NUCLEAR REGULATORY COMMISSION

Title: Advisory Committee on Reactor Safeguards
 AP1000 Subcommittee: Open Session

Date: Tuesday, April 5, 2016

The purpose of this meeting is to review the exemption request in the Levy Nuclear Plant Units 1 and 2 Combined License Application. These exemption requests include departures from the AP1000 certified design, which contain: one, passive core cooling system condensate return; two, main control room dose; three, main control room heatup; four, hydrogen vending inside containment; and, five, neutron flux doubling algorithm compliance with IEEE-603. So there are five exemptions, we

Heat Loss Through Pressurizer

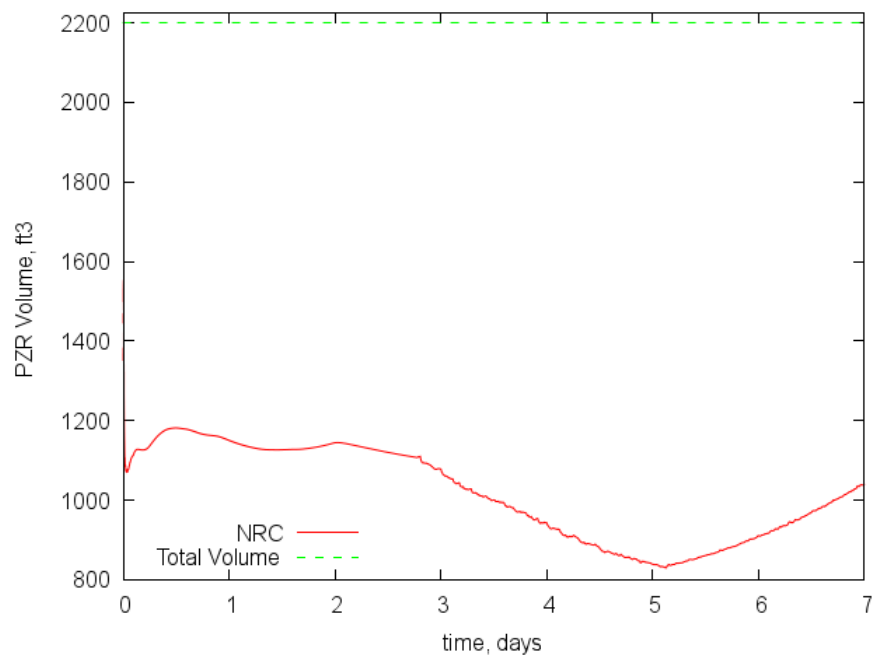
- Primary heat loss concern from RCS is through pressurizer
 - Has insulated and uninsulated surfaces
 - The uninsulated surfaces (supports, heater sheaths) account for almost half of the heat losses through the PZR under certain conditions
- Analyses performed to justify effective heat transfer coefficient (HTC) applied to PZR outer surface in RELAP5 and LOFTRAN
 - Effective steady-state HTC conservatively bounds transient conditions
 - Modeling of PZR heat losses is conservative:
 - Consistent with NRC staff calculations
 - Supported by data from literature

- Staff confirmatory analyses indicate a further margin of 50% could be applied to the heat losses and have the RCS remain subcooled for a minimum of 72 hours
- Multiplication factors used to account for heat losses beyond through-insulation heat loss are supported by data from literature
 - Laboratory testing showed through-insulation ranged from 28% to 52% of total heat loss
 - Convective air flow will be reduced significantly during SBO

Loss of Subcooling Transient Analysis

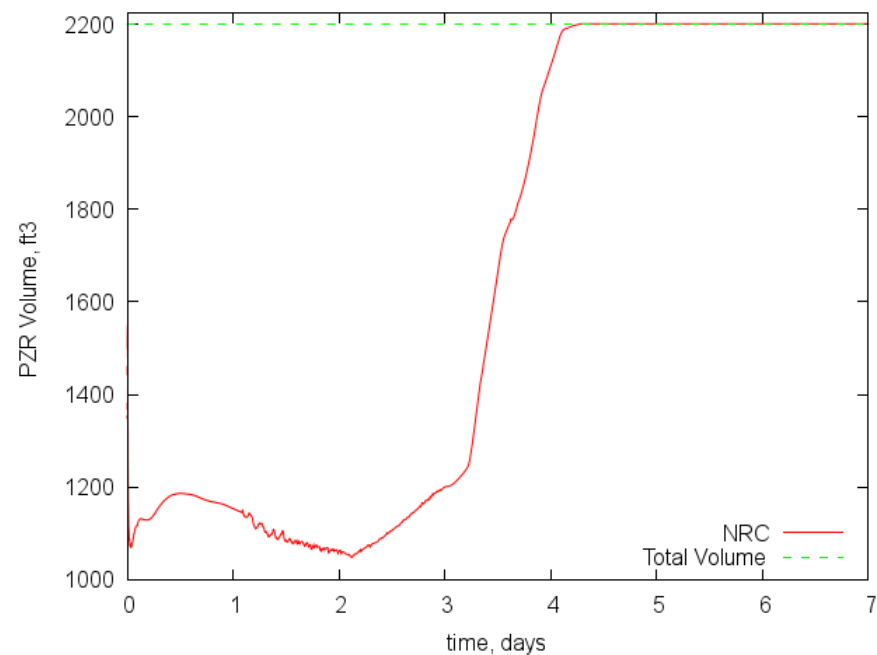
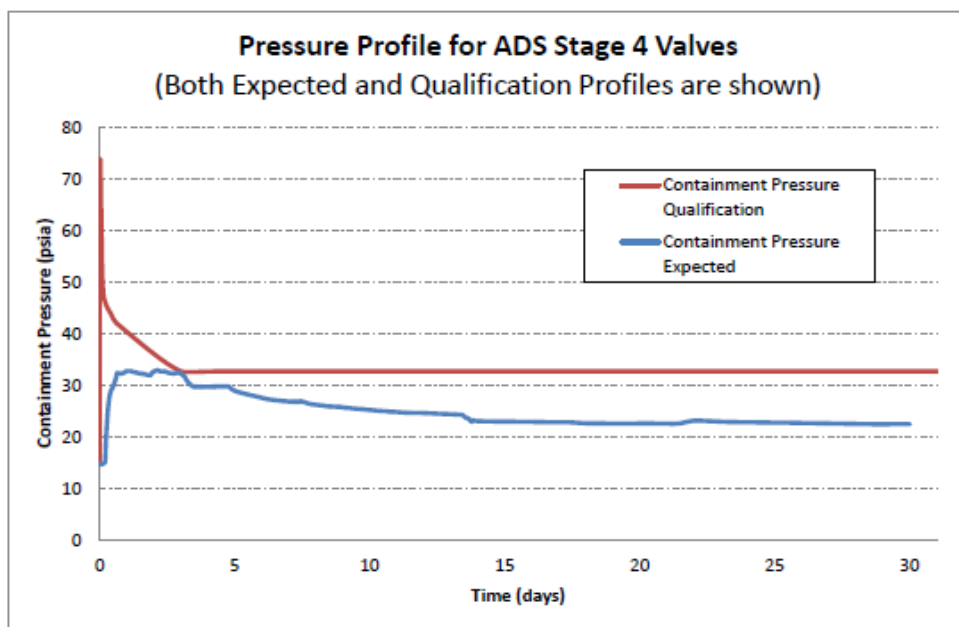
- DBA analyses show loss of subcooling does not occur within 72 hours
 - Ambient heat losses do not adversely impact Chapter 15 DBA analyses
 - Consistent with staff confirmatory analysis
- No adverse impact to safe shutdown analysis (420 F in 36 hours)
- Analyses show loss of subcooling occurs within 14 days
 - PRHR HX performance does not degrade
 - Supported by test results from APEX facility (NRC SBO testing for AP600 and AP1000)
 - Consistent with staff confirmatory analysis

Transition to Open Loop Cooling Equipment Qualification Envelope

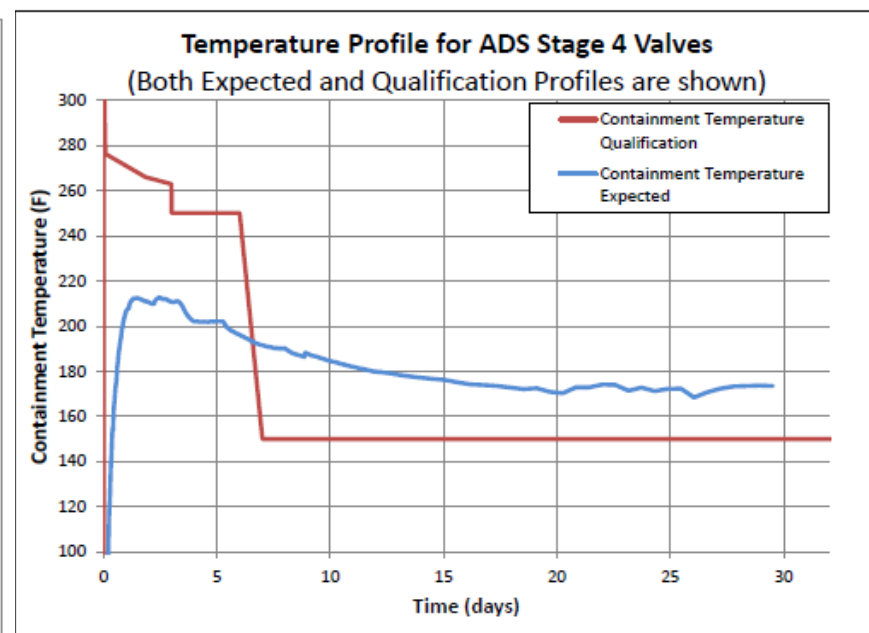
1 So this next slide, it shows the analysis done by the applicant in part of the RAI
2 response and this shows an EQ envelope as well as expanded containment conditions during an
3 extended event that would use passive RHR.

7 So to resolve that issue, they did a scaling analysis using the Arrhenius Equation
8 and they were able to show that the scaled EQ envelope does bound these containment conditions
9 over 30 days.

MCR Temperature and Humidity

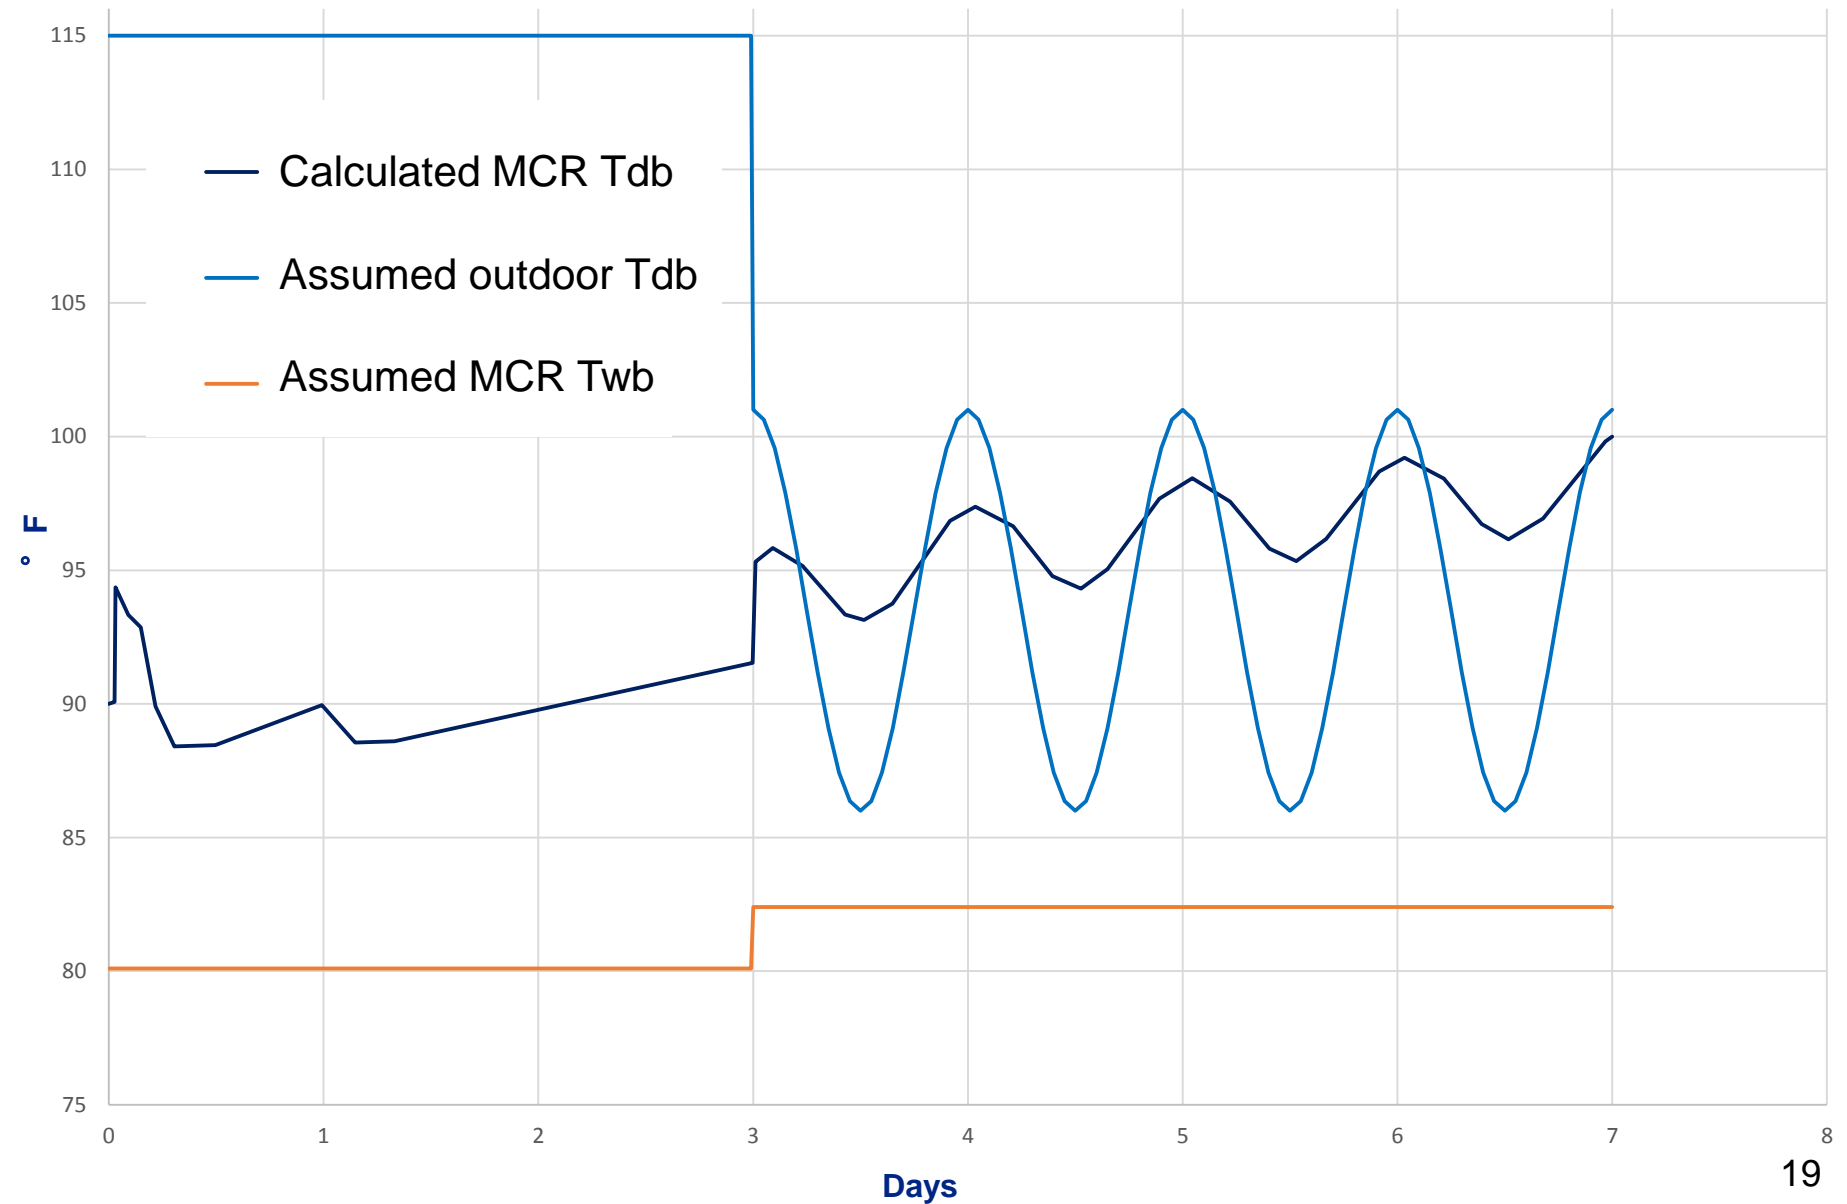
- Two periods of interest:
 - 0-72 hours (VES in operation)
 - 3-7 days (ancillary fans in operation)
- New heat load (result of revisions to heat loads plus addition of load shed) in GOTHIC analysis changes temperature profile
- Due to acceptance criteria, both dry bulb and wet bulb temperature (humidity) are important parameters
 - Human Performance: WBGT < 90 F
 - Equipment Qualification:
 - 0-72 hours - < 95 F and 60 % Relative Humidity
 - 3-7 days - < 110 F and 35 % Relative Humidity

- Staff reviewed GOTHIC analysis and found it conservatively captured dry bulb MCR temperature with the new heat load and load shedding (profile on slide 19)
- Applicant assumed a constant ambient dry bulb temp. of 115 F
- Humidity calculated separately by applicant
 - Value asymptotically approaches steady state, due to dry air input from VES bottles and subsequent leakage from the MCR
 - Applicant used initial conditions of 75 F, 60% RH (the nominally limiting values) to determine that assumed value was conservative
 - While staff agrees that those values are the highest expected in the MCR, staff performed a confirmatory calculation using 75 F, 100% RH (TS limited value) and found that maximum T_{wb} was ~79 F, less than the 80.1 F assumed in the analysis
- MCR substantially lower than 90 WBGT during first 72 hours
